Video Products Technical Bulletin 30-2004-146R

SUBJECT: RETRACE LINES; NO PICTURE

MODEL: **PVM-14L1**
PVM-14L1//C
PVM-14L1MDE
SSM-14L1

Figure 1

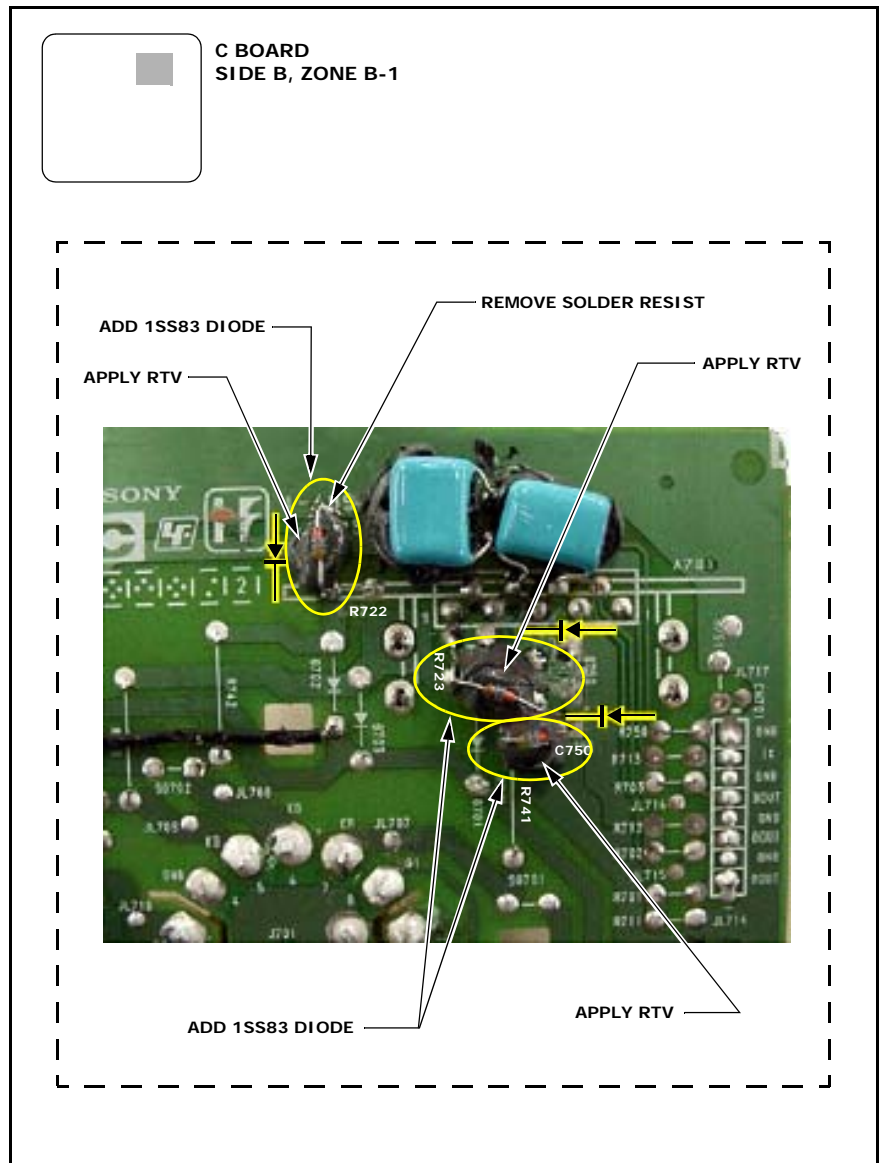
C Board (Side B, Zone B-1)

1. Scrape to remove the coating of solder resist over the GND point near R722 as shown in Figure 1.
2. Add 1SS83 diodes between:
 - (A) R722 (left) GND
 - (B) R723 (bottom) . . . C751 (GND)
 - (C) R741 (top) C750 (negative)
3. Apply RTV as shown in Figure 1.

Figure 2

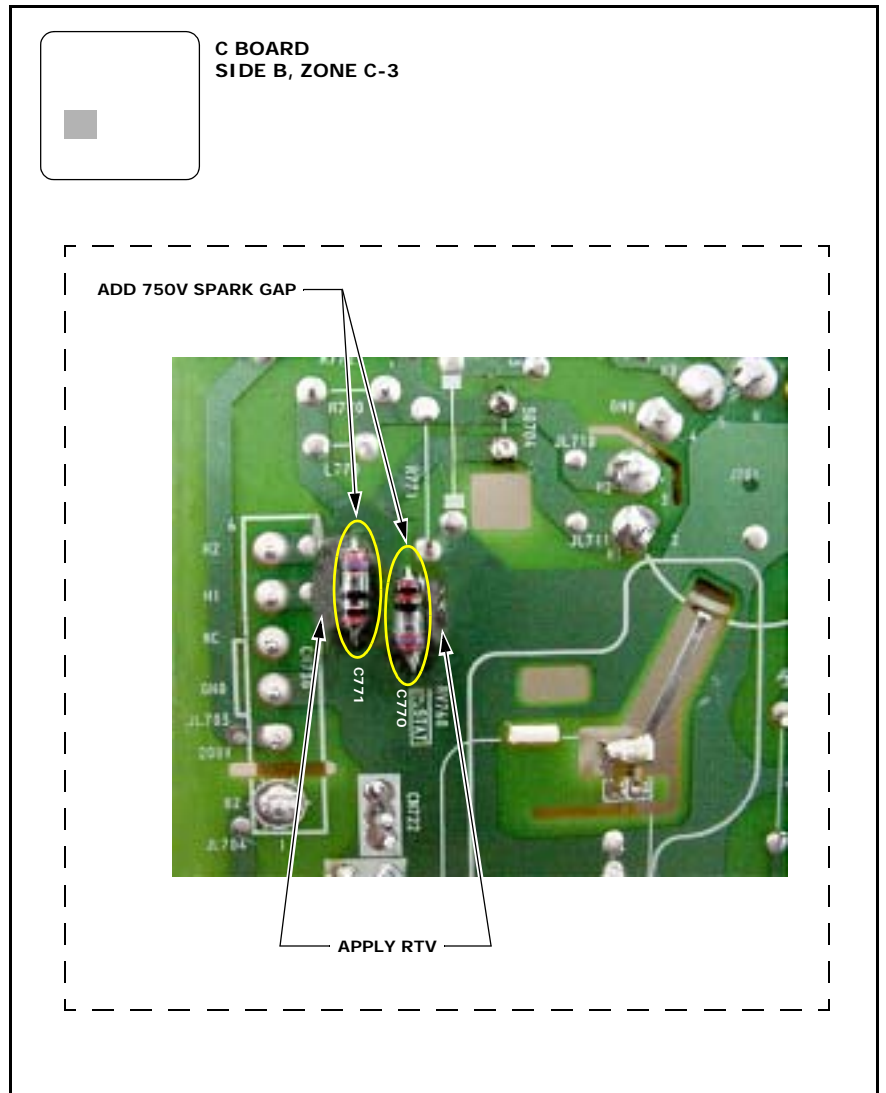
C Board (Side B, Zone C-3)

4. Add 750V spark gaps to C771 and C770. (See Figure 2.)
5. Apply RTV as shown in Figure 2.
